FINAL MITIGATION PLAN

**Stony Fork Restoration Site
Johnston County, North Carolina
DMS Project Number 97085
DMS Contract 6830
USACE AID SAW-2016-00875
DWR Project Number 2016-0372**

NC Department of Environmental Quality
Division of Mitigation Services
1652 Mail Service Center
Raleigh, NC 27699
September 5, 2018

Buffer Mitigation - Sheet 2

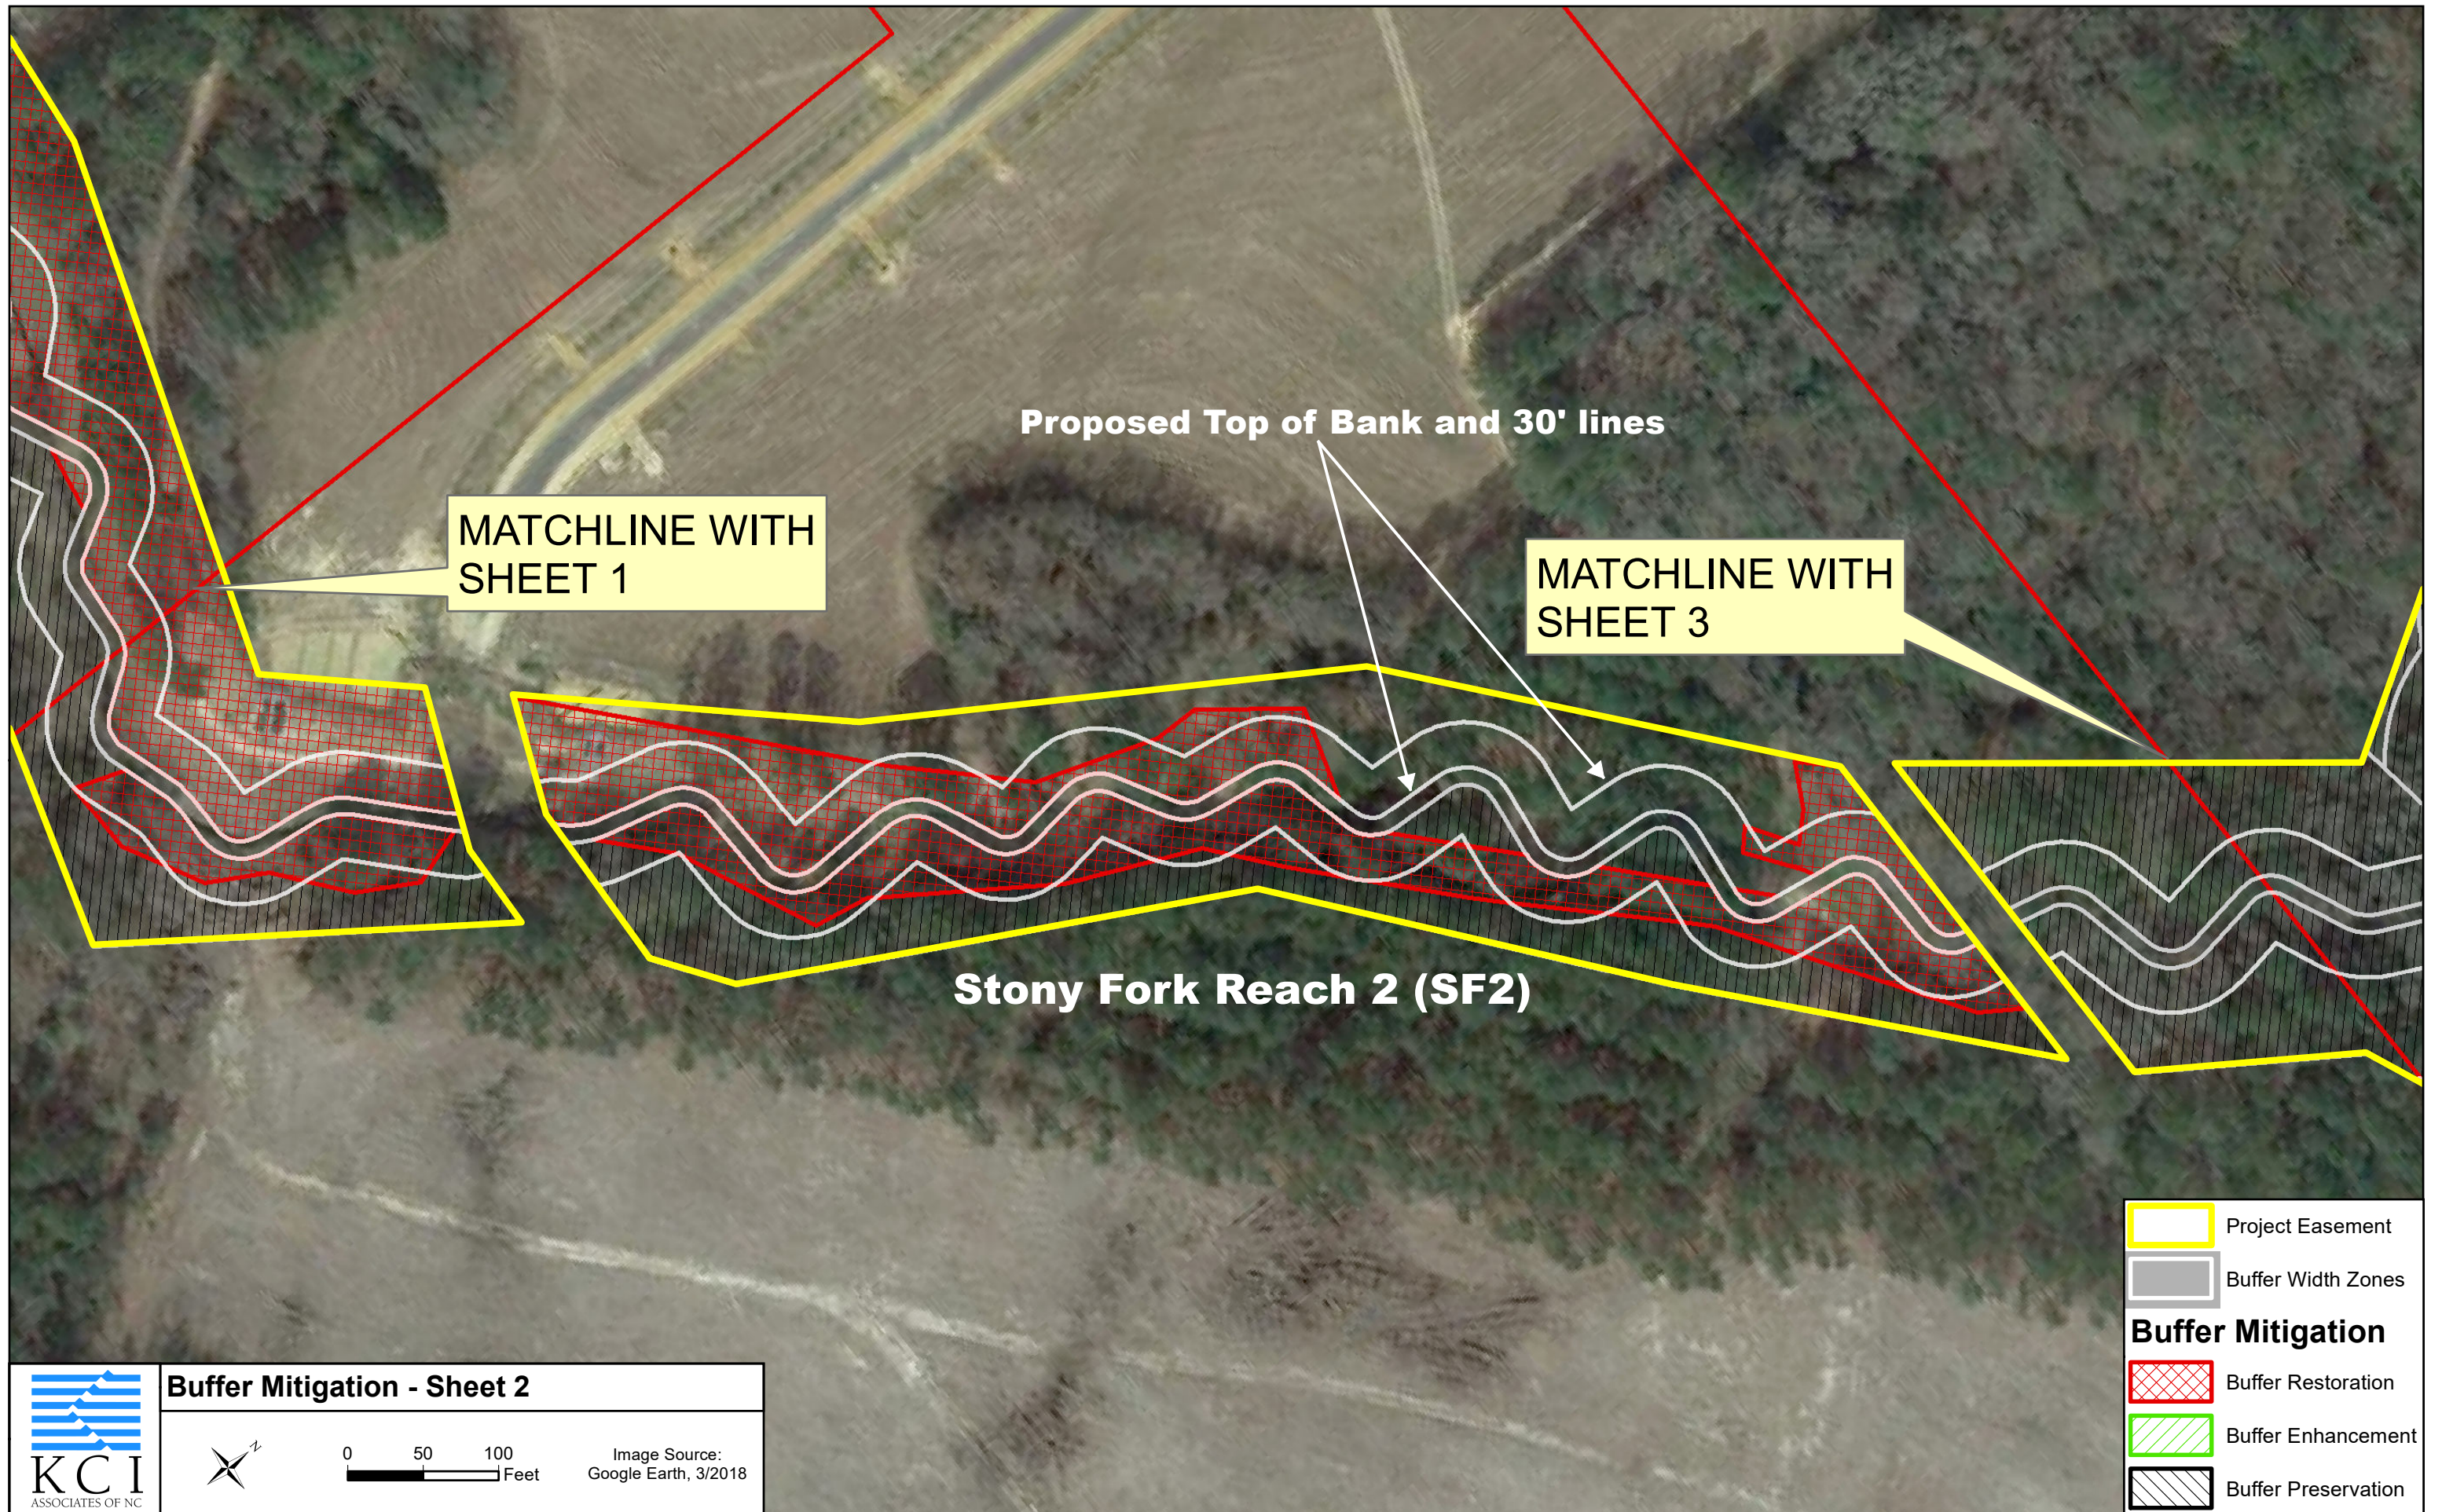
- Map Sheet #2-Shows the west side of the farm path between T1/SF confluence and T2/SF confluence proposed for Preservation credit. However, the viability letter indicates the pine plantation is not suitable for any credit. Please revise credits accordingly to comply with the viability letter.
